# NOTICE OF DECISION

1600 Schurman Way / Schurman Way Site Plan

<b>Land Use Application Nos.:</b>	SPR-21-012 (Site Plan Review – Type 2) SEP-22-001 (SEPA)
<b>Applicant &amp; Property Owner:</b>	Mike Leboki 7416 NE 101 <sup>st</sup> Street Vancouver, Washington, 98662
<b>Site Location:</b>	1600 Schurman Way Woodland, WA 98674
<b>Parcel &amp; Size:</b>	504212017, 2.04 Acres
<b>Zoning Designation:</b>	Light Industrial, I-1
<b>Date Application Received:</b>	December 8, 2022
<b>Notice of Application &amp; Likely DNS issued:</b>	February 1, 2022 [See: case # SEP-22-001]
<b>Comment Period &amp; SEPA Appeal Period Ended:</b>	February 23, 2022
<b>Notice of Decision Issued:</b>	March 1, 2022
<b>DRC Decision:</b>	Approve with Conditions

# Schurman Way Site Plan

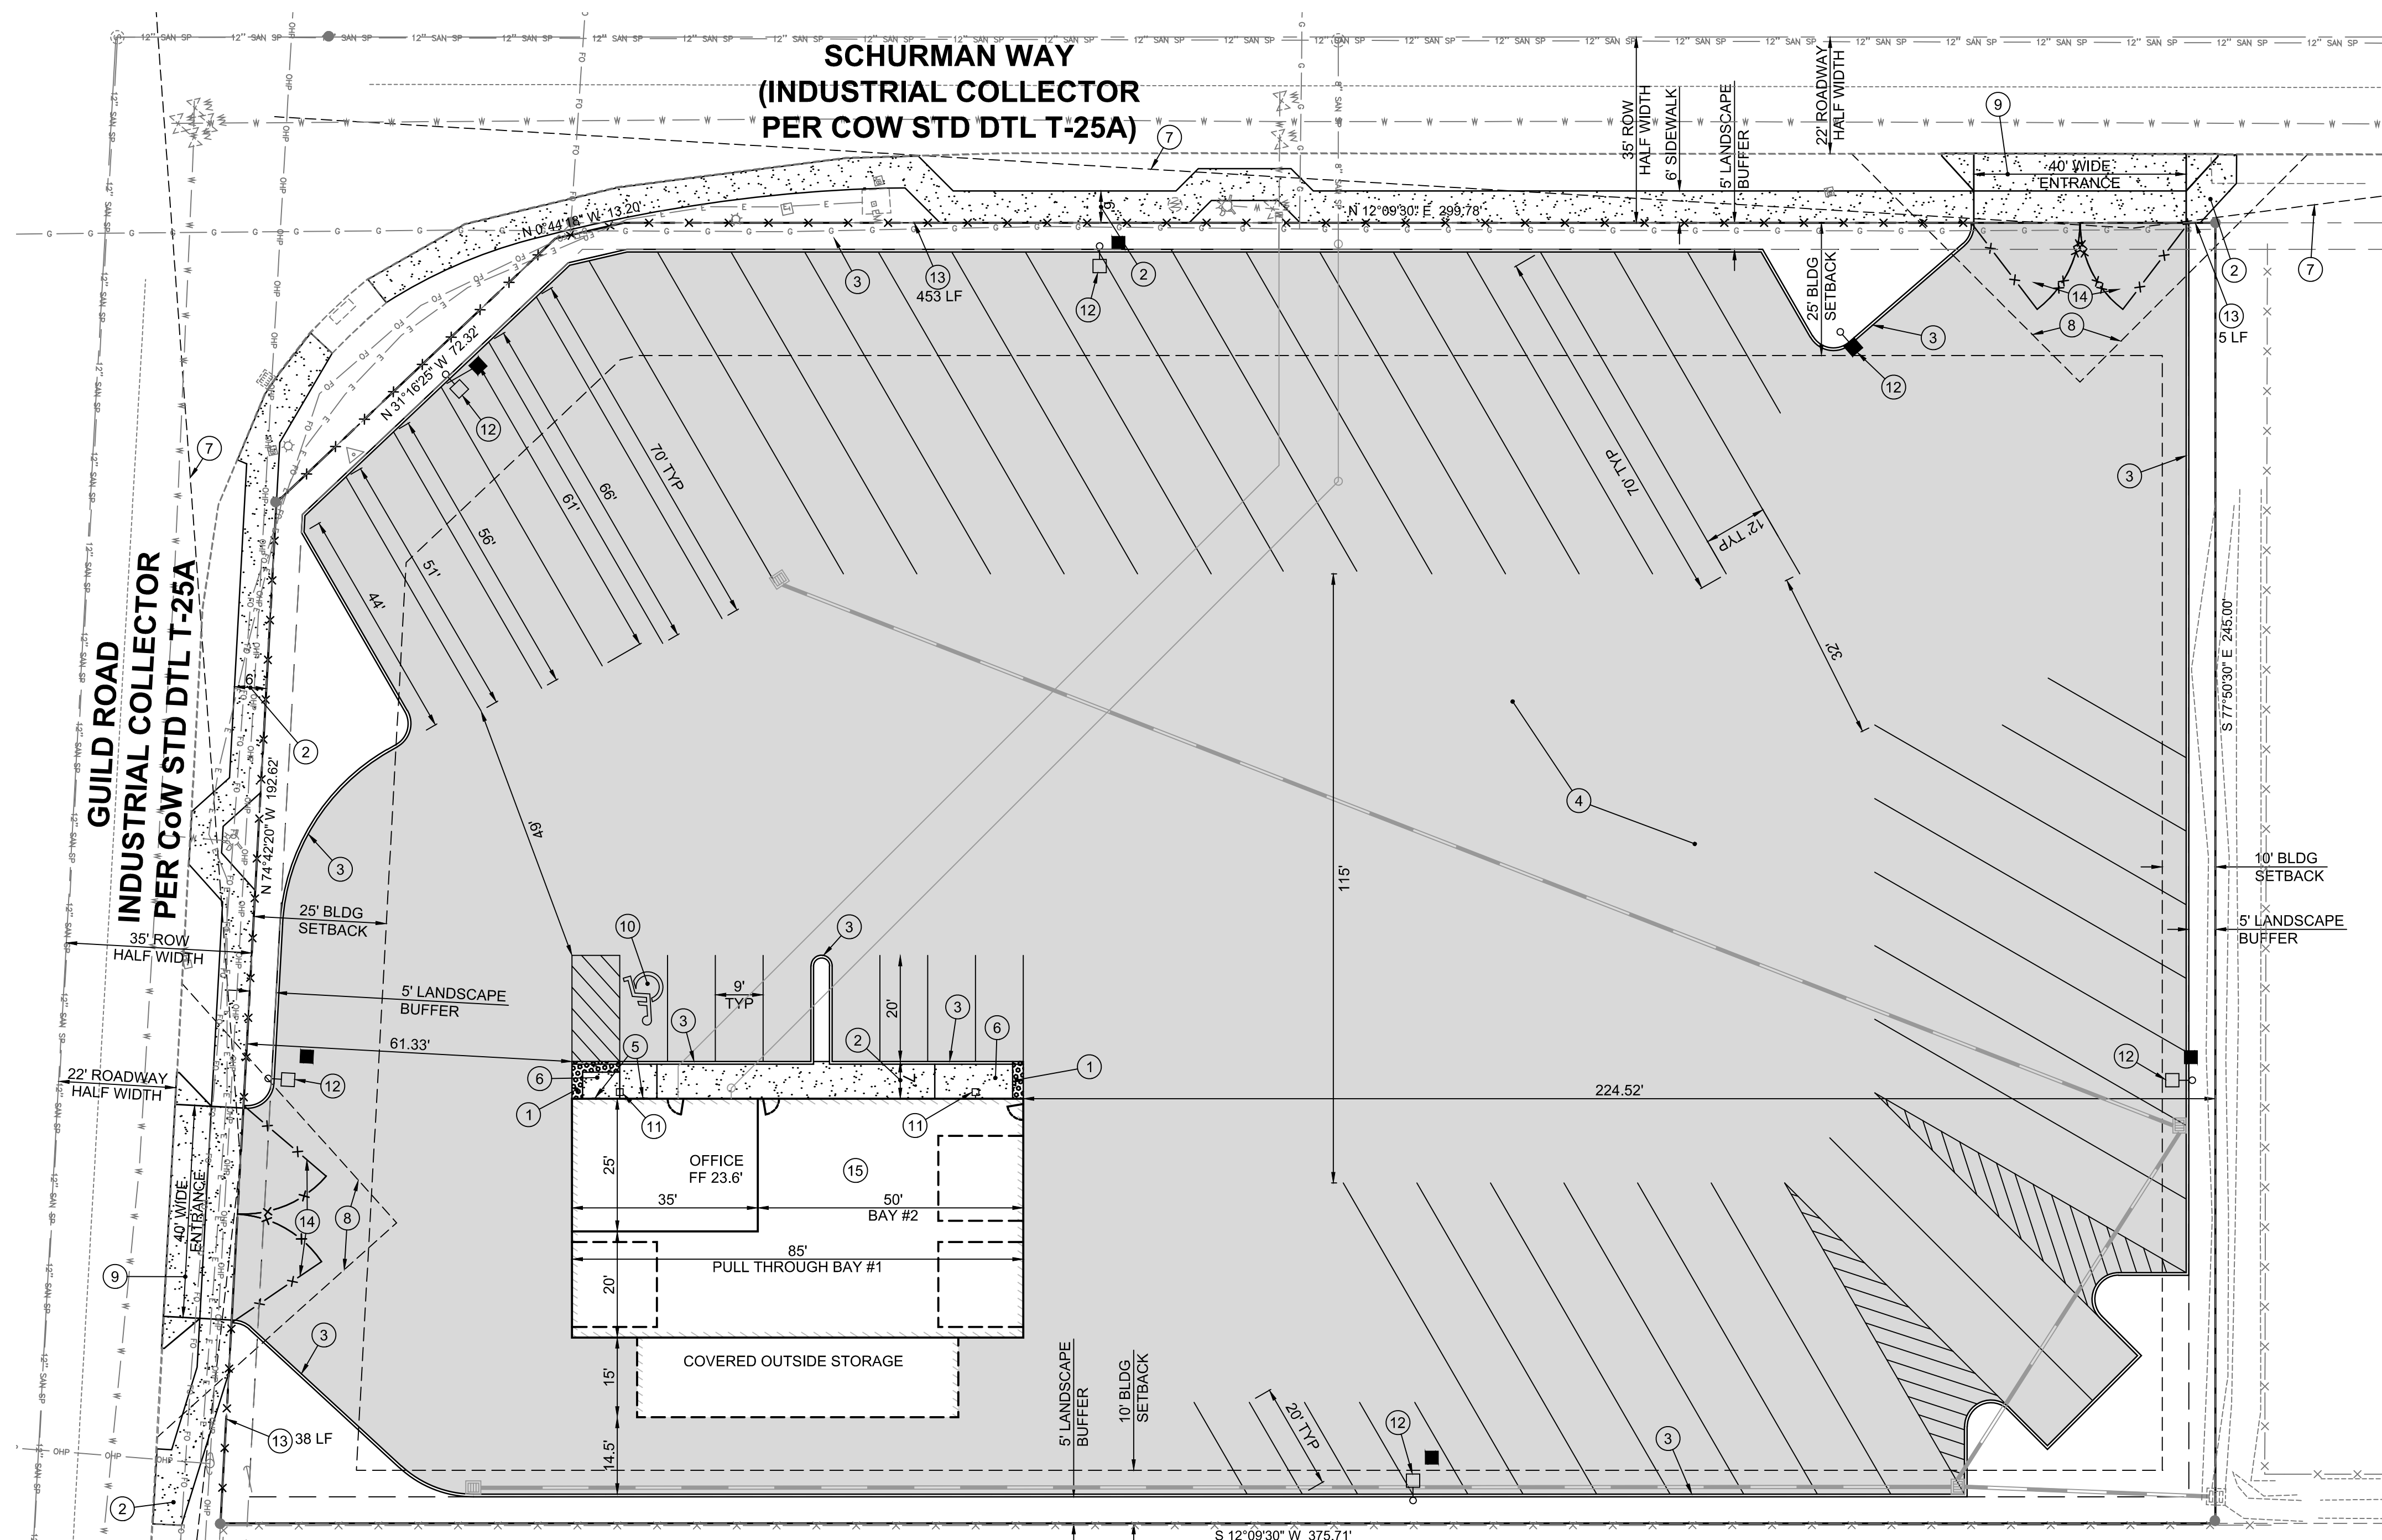
**Finding 44:** The site plan shows one ADA parking spaces. This meets building code requirements.

**Finding 45:** Per Washington State Code 51-50-0429 Section 429, electric vehicle charging infrastructure must be provided for at least ten percent of provided parking spaces. For the proposed 12 parking spaces, this would require 2 EV spaces be available. *See Condition #15.*

**Finding 46:** As outlined in WMC 17.56.040, parking and loading facilities shall be located at the side or rear of buildings. Plans indicate parking is located at the side and rear of proposed building.

14. Building construction plans shall be submitted to CCFR separately, along with any fire alarm and/or fire sprinkler alterations.
15. Per Washington State code, please modify final plans to note the inclusion of at least 2 parking spaces (10% of proposed parking spaces, rounded up) equipped with required electric vehicle charging infrastructure.
